Service Part Throttle Cable Is Too Short

Product: Groundsmaster 3280-D

May 31, 2011

Installation Diagram for Service Part Throttle Cable

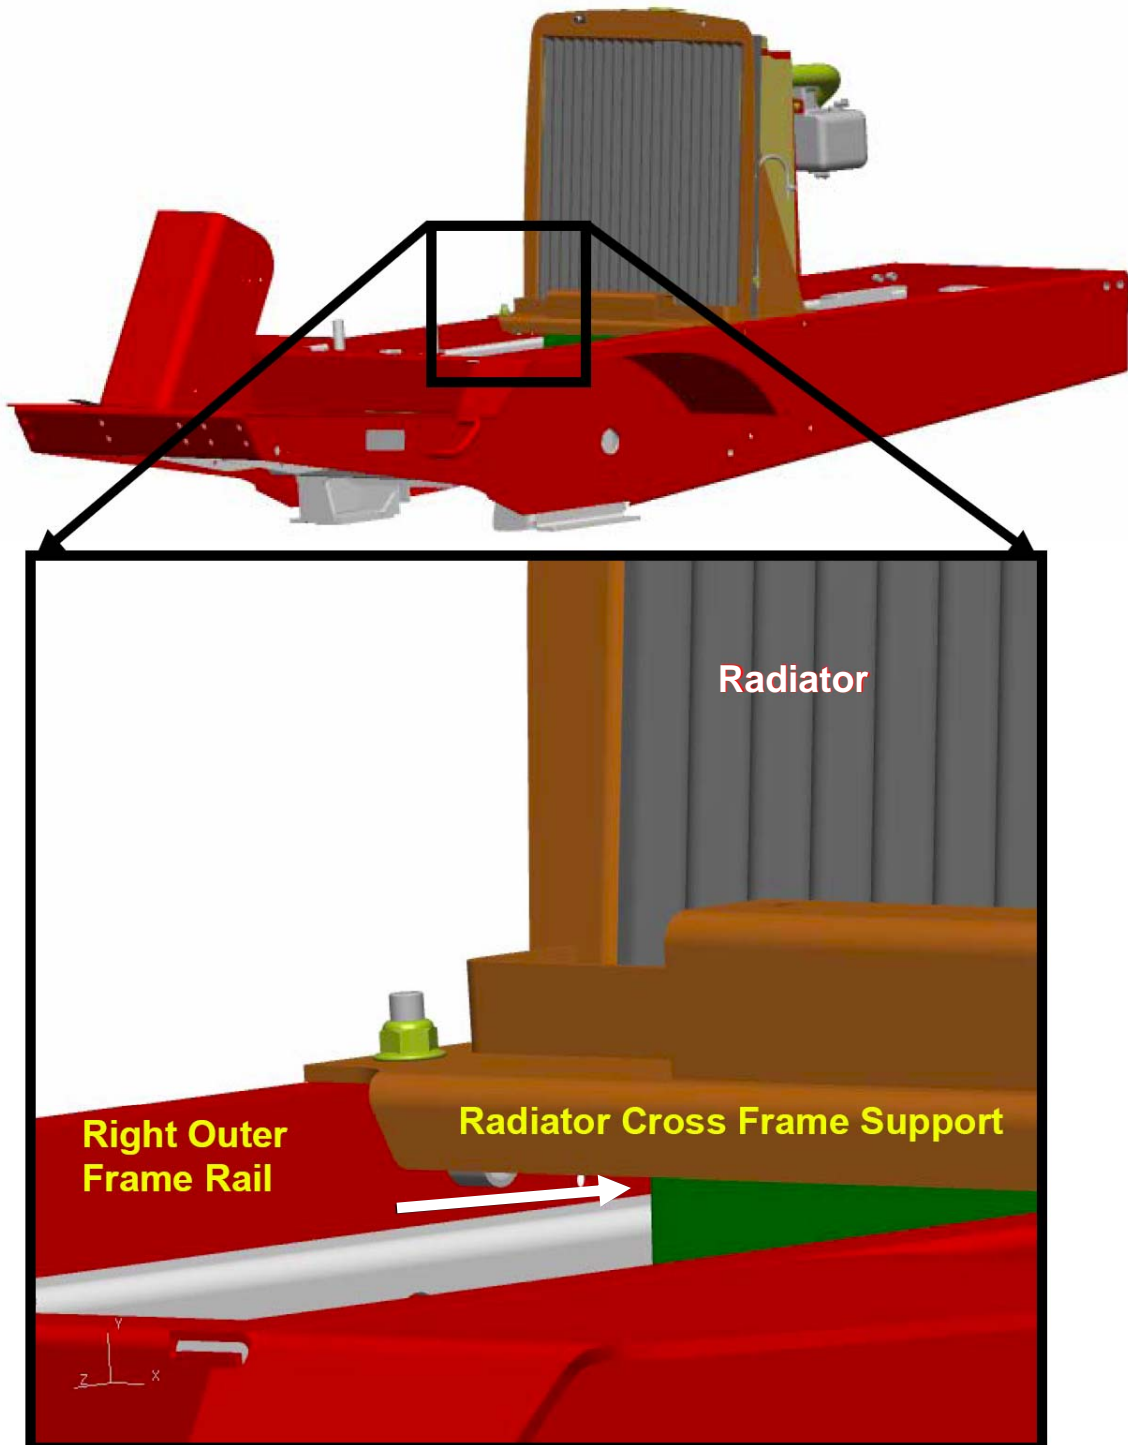
Throttle Cable ([108-2033](#)) originally installed in Groundsmaster 3280-D 3320 has become obsolete as of late 2009 production. This part number has been cross-referenced to Throttle Cable ([117-0824](#)). This new cable is approximately 2.3" (58 mm) shorter than 108-2033; it requires different routing as it runs past the right side of the radiator leading back to the engine.

Route Throttle Cable (117-0824) through the opening just below the Radiator support and above the inner right side frame channel (gray colored in this image) back to the engine compartment.
